Pierre Auger Observatory

Surface Detector Electronics Upgrade

UUB Pre Prototype Production Report

UUB Model version: SDE-002-002-IE00

Figure 4: Valid_Alim modification in schematic (page 11)

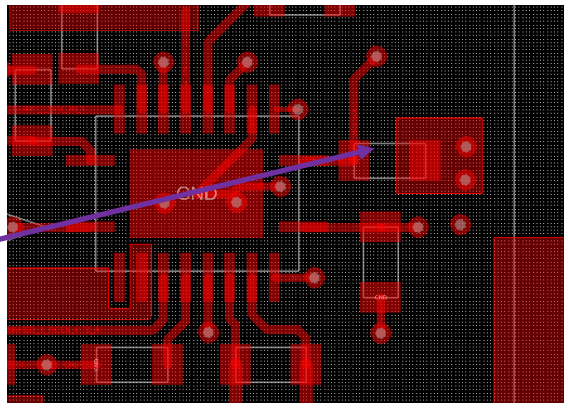
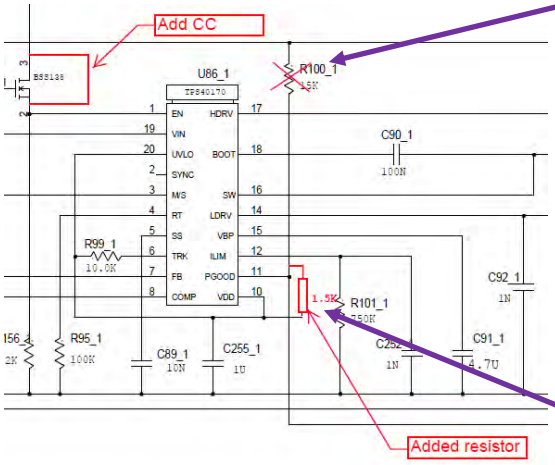
The Valid_Alim is generated by 1 Volt DC/DC converter, from its “power good” pin.
R100_1 is removed.
A 1,5 K Ohms 1 % resistor, 0603 package must be added between VDD (U86_1 pin 10) and PGOOD (U86_1 pin 11).

- R1_X, 1.5 KOhms 1% 0603 (available in UUB BOM, ref.: RES-068)

Figure 6: Pin 2 &3 Swap connection.

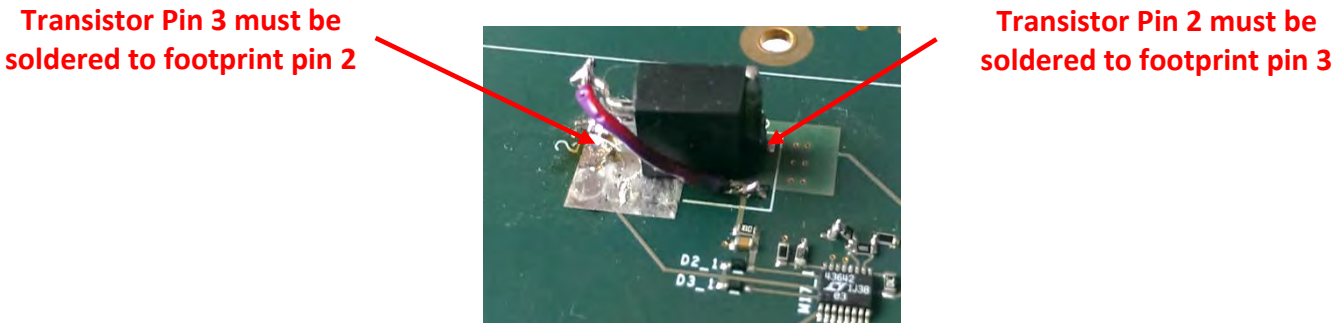
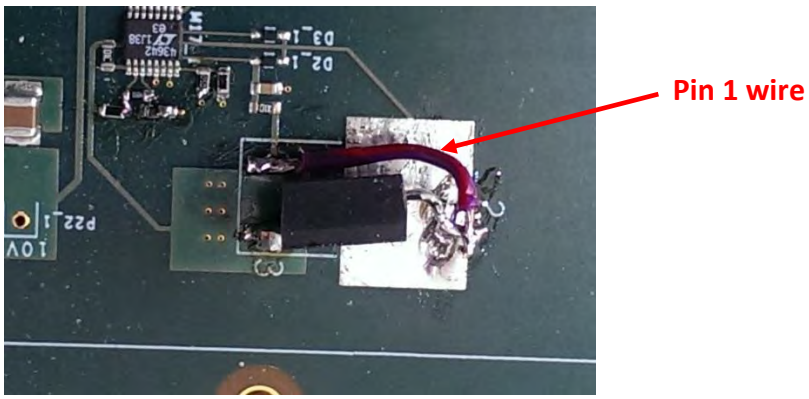
Wrong footprint for Q4_1 transistor. Pins 2 & 3 must be swapped.

The connection between transistor pin 1 to the footprint must be made by a wire.

Figure 8: DAC7551 Power supply modifications (Schematic page 6).

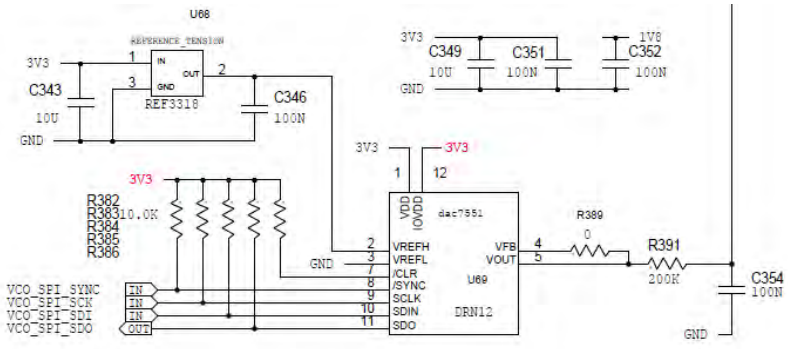
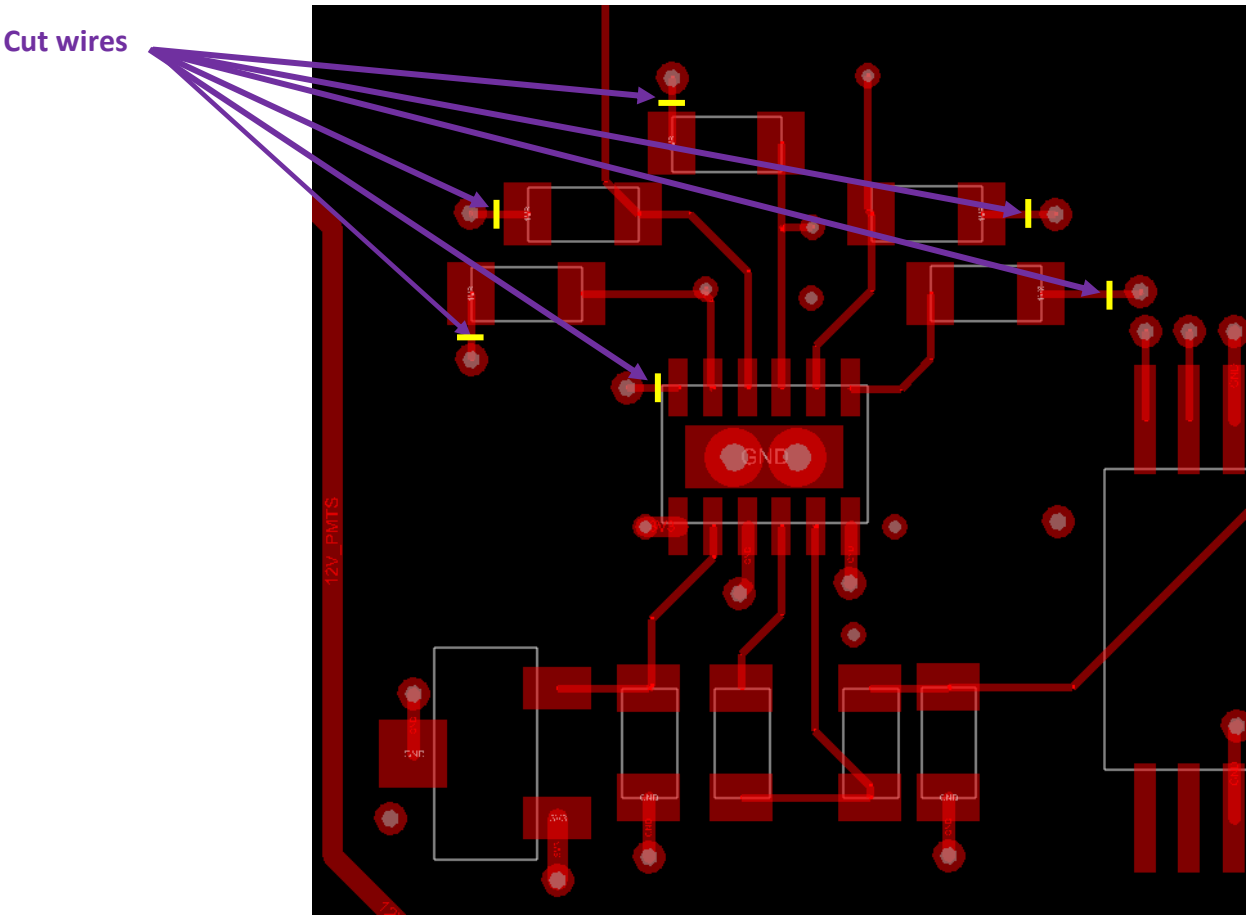
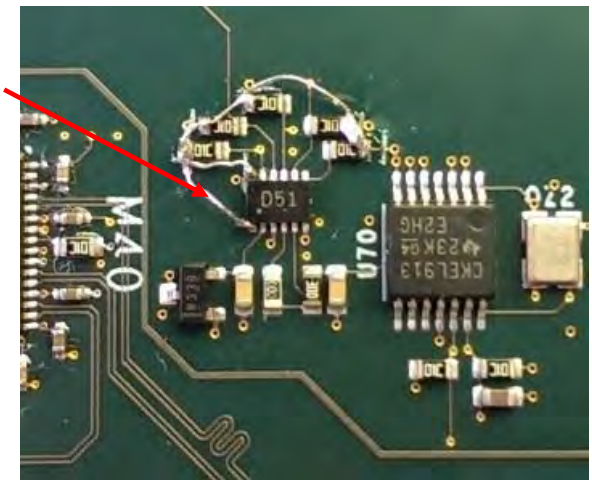
DAC7551 IOVDD pin must be connected to 3,3 Volt (1,8 volt previously) power supply and the pull-up resistors R382, R383, R384, R385 & R386 too.

3,3 Volts power supply modifications. Add wire between U69 pin 12 and resistor R382, R383, R384, R385 & R386

Figure 14: U36, pins 20 & 23 wire connection.

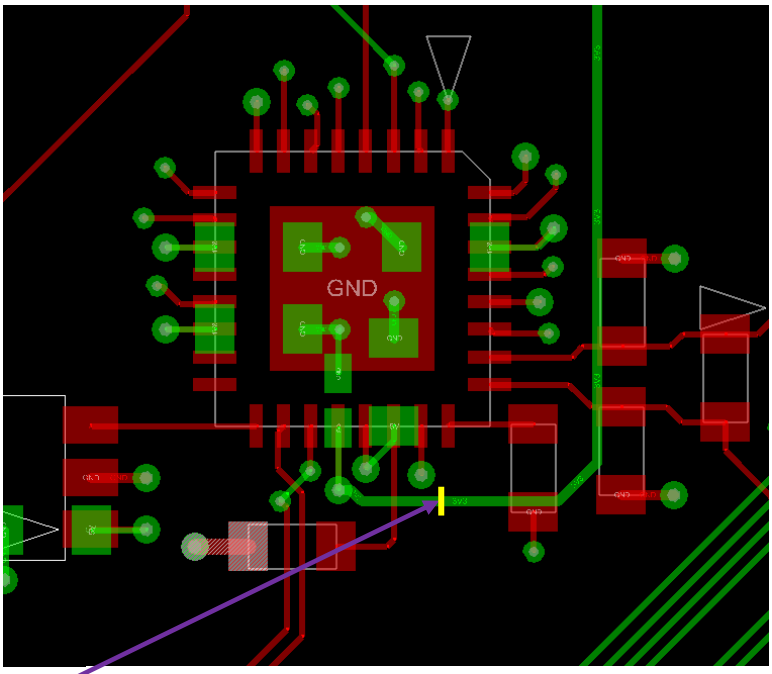
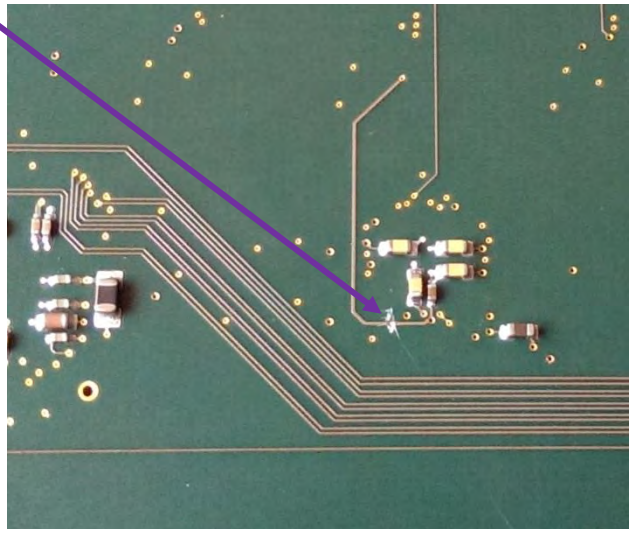
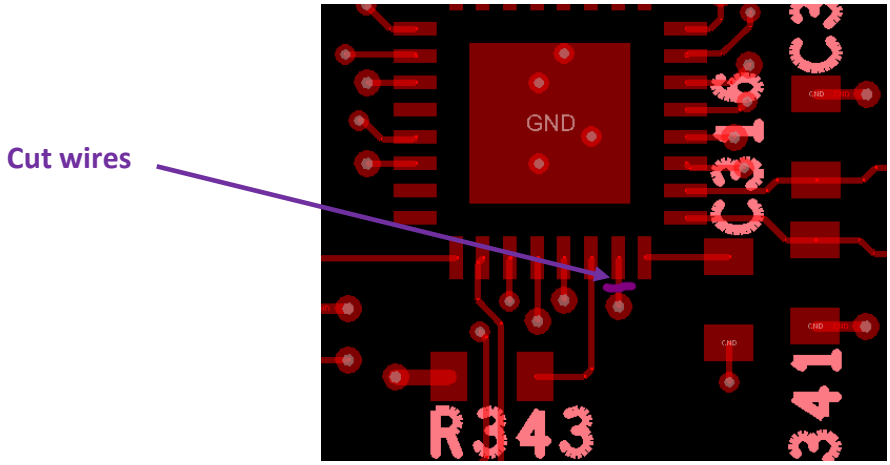
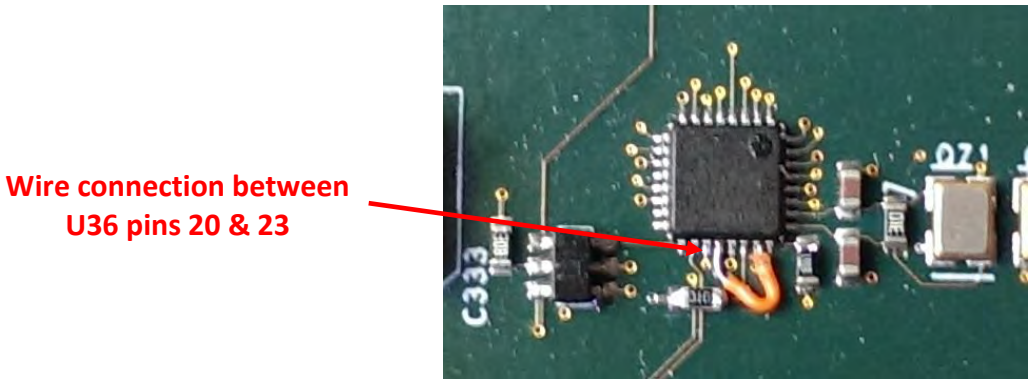
U36 pin 20 must be disconnected from 3,3 Volts and connected to U36 pin 23.

U36 pin 23 must be disconnected from 1,8 Volts and connected to 3,3 Volts.

Figure 15: R343 resistor value changed to 1 kOhms (Schematic page 4).

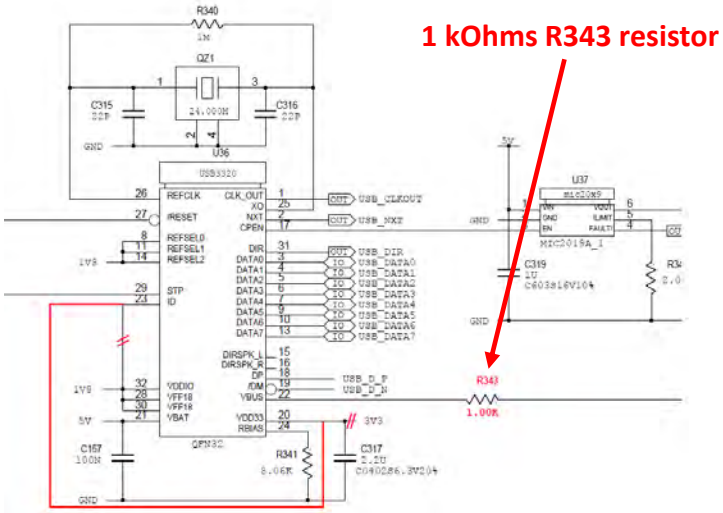
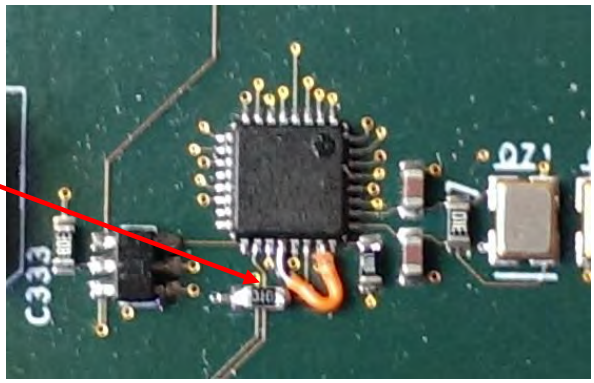
The VBUS R343 resistor value is bad in the Bill Of Material. It must be 1 kOhms instead 10 kOhms (NCR n° 2-43).

Figure 17: Missed FE5 coil (Schematic page 4).

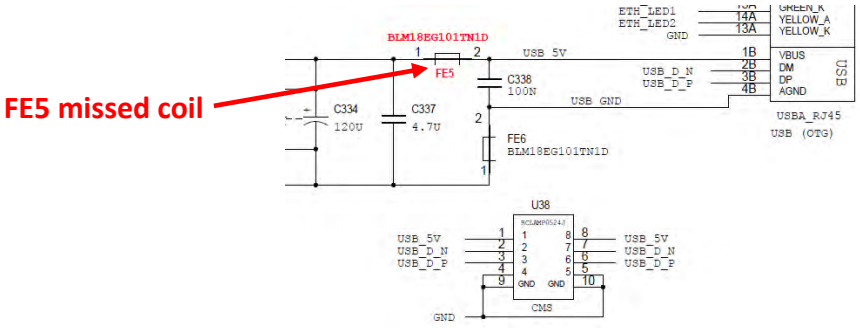
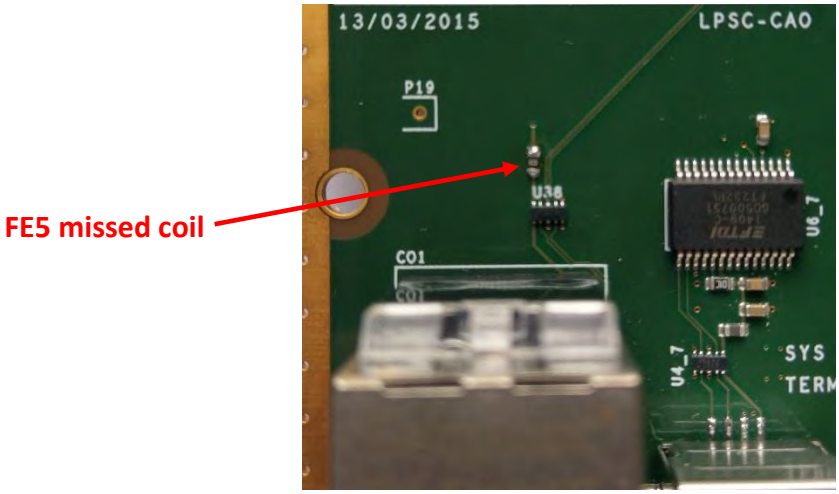
The FE5 coil has been forgotten in the BOM. A 0 Ohm resistor or a short-cut could be put (NCR n° 2-42).

Figure 19: +/- 3,3 Volts Enable modification (Schematic page 10).

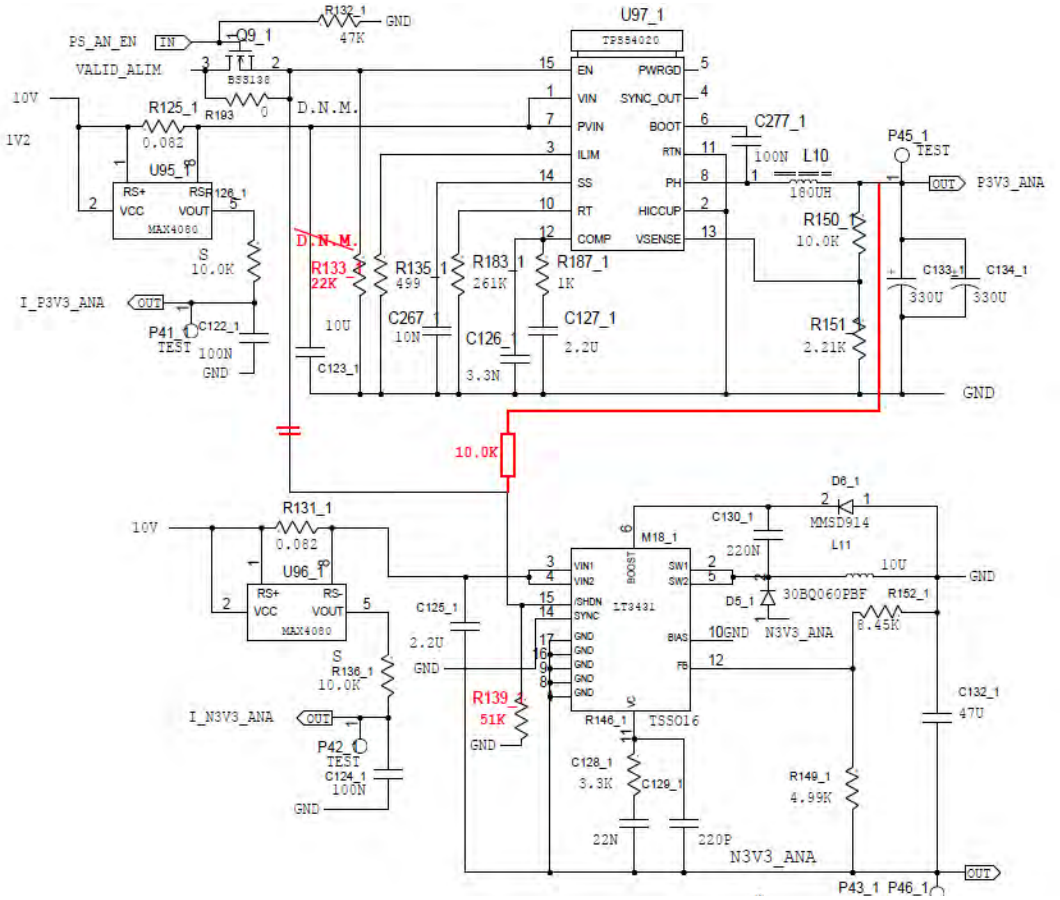
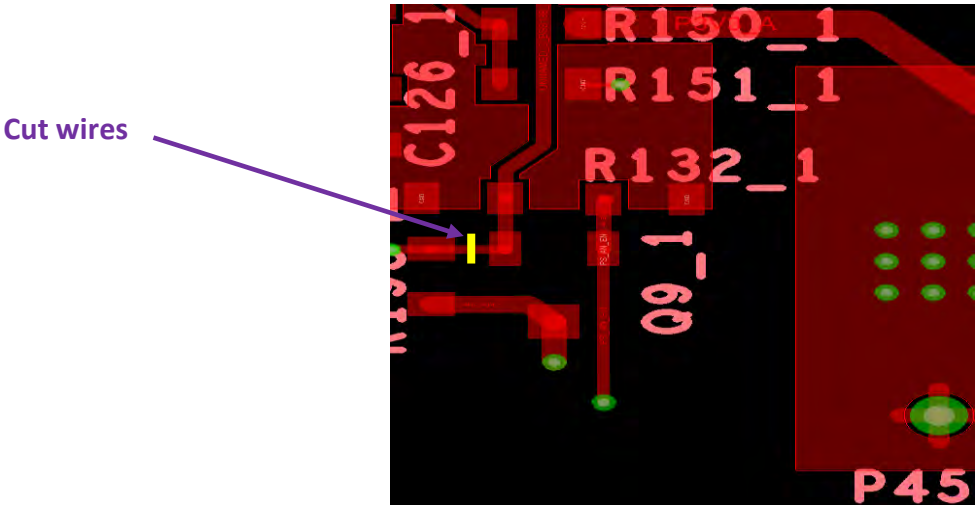
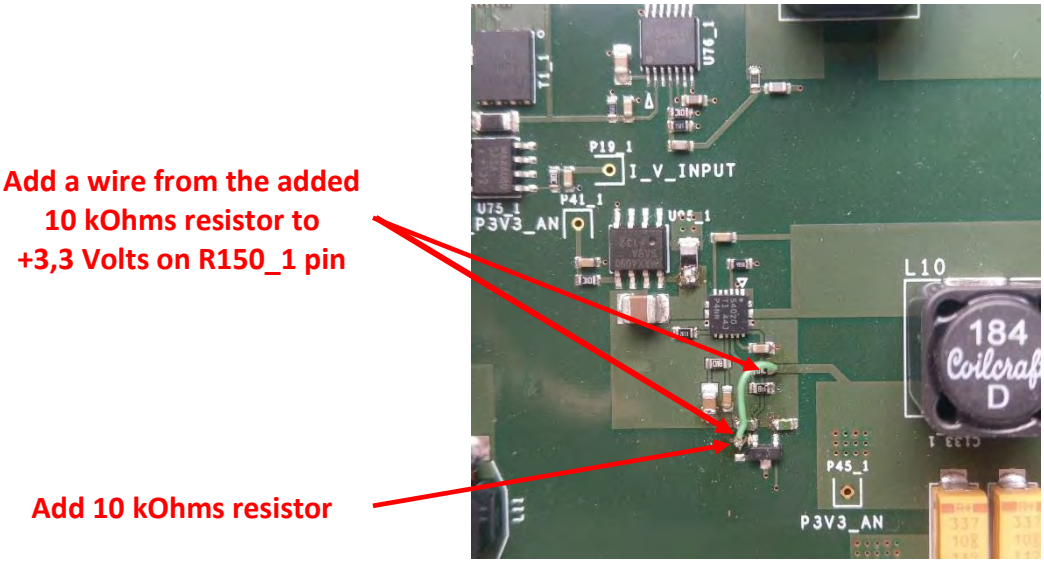
For the SDE-002-002-IE00 UUB board only, the +/- 3,3 Volts Enable will be send from the Slow-Control micro-controller (3,3Volts) to U97_1 +3,3V DC/DC pin15 (EN) and U18_1 -3,3V DC/DC pin 15 (/SHDN). The +3,3V DC/DC output will enable the -3,3V DC/DC enable.

- R2_X, 10 KOhms 1% 0603 (available in UUB BOM, ref.: RES-017)

Figure 22: BOTTOM side R139_1 resistor value modification.

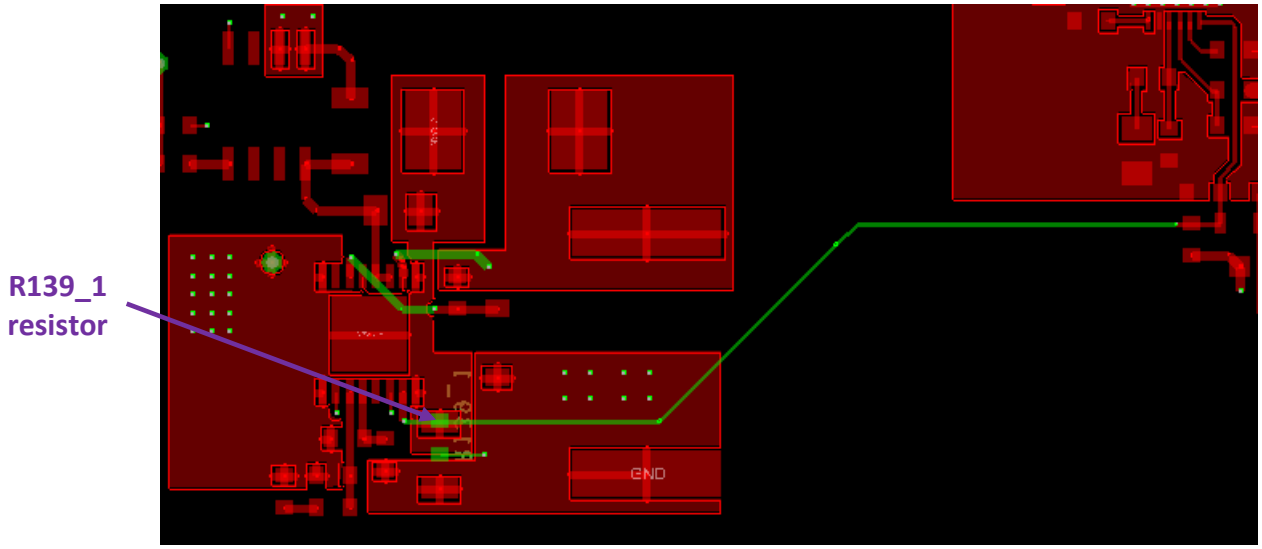
R139_1 resistor value must be changed from 22 kOhms to 71 kOhms.

Figure 23: FPGA boot configuration jumper (Schematic page 23).

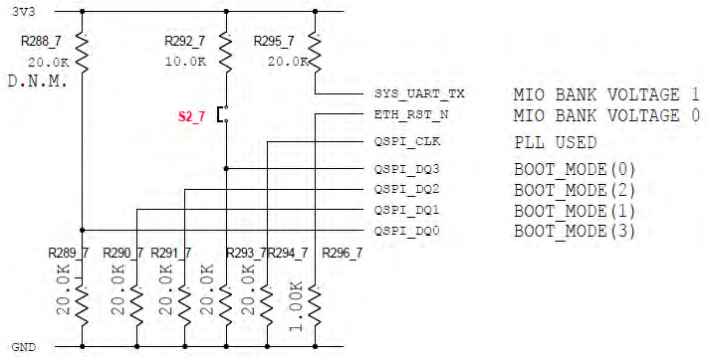
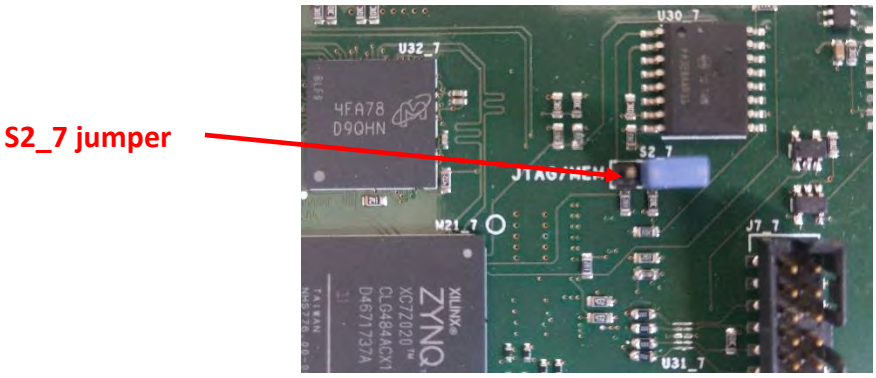
The boot configuration jumper (S2_7) has been forgotten in the Bill Of Material (NCR n° 2-1). It must be added.

Figure 25: GPS antenna configuration resistor (Schematic page 3).

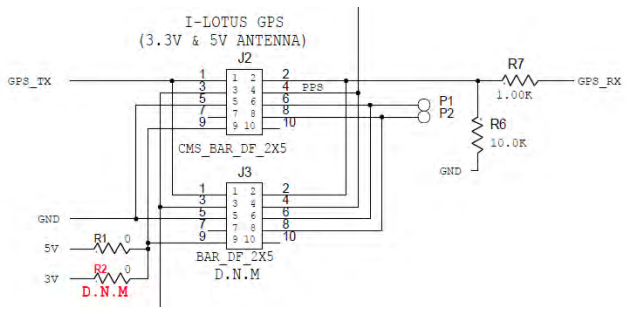
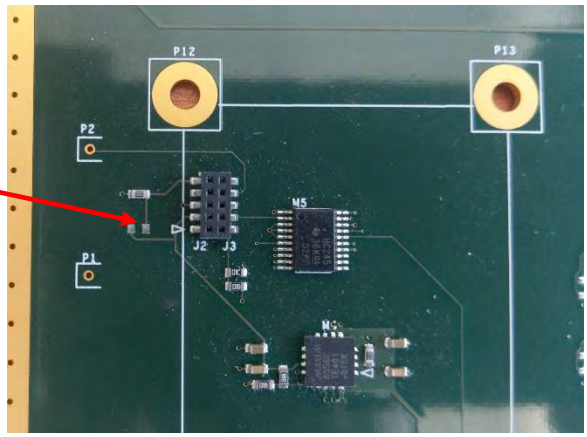
The GPS antenna could be powered by 2 types of voltages, 3 Volts or 5 Volts. On the board this choice is made by R1 and R2 0 Ohm resistors. Presently, the 2 resistors are soldered on board (NCR n° 2-2). R2 resistor must be removed.

Figure 27: Slow-Control RESET configuration resistors (Schematic page 12).

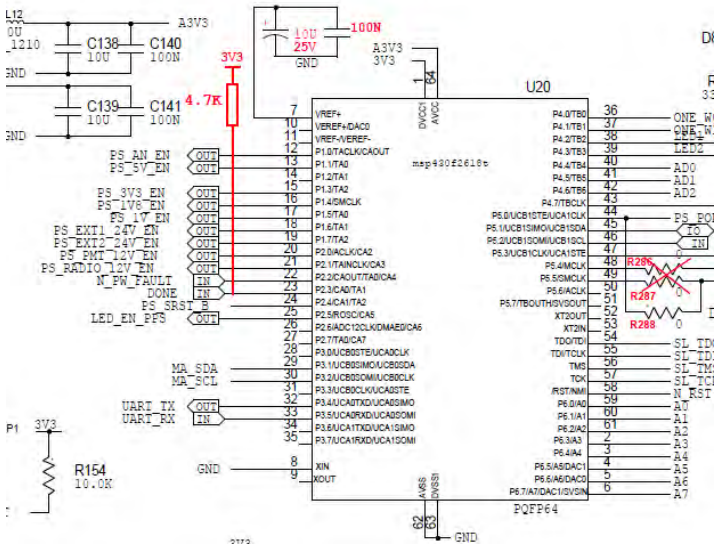
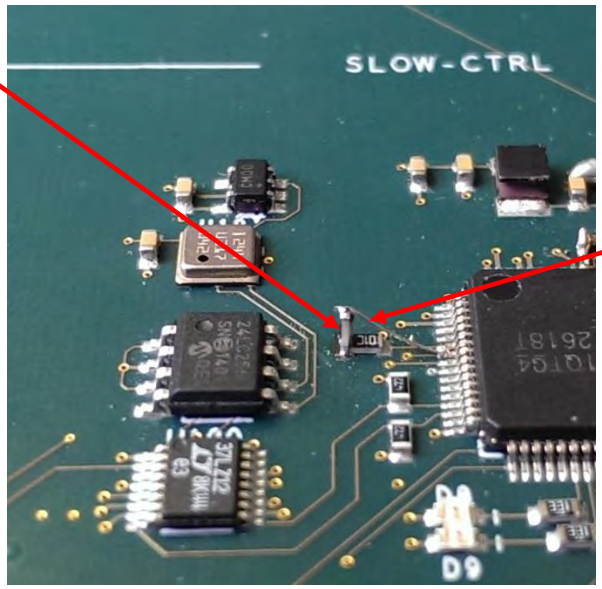
4,7 kOhms 1% and 0603 package Pull-up resistor must be added between 3V3_SLOW_CTRL and U20 pin 23 (schematic page 12).

DONE pull-up 4.7 kOhms resistor added

Wire connected to pin 23 on U20 and the added resistor

- R3_X, 4,7 KOhms 1% 0603 (available in UUB BOM, ref.: RES-043)
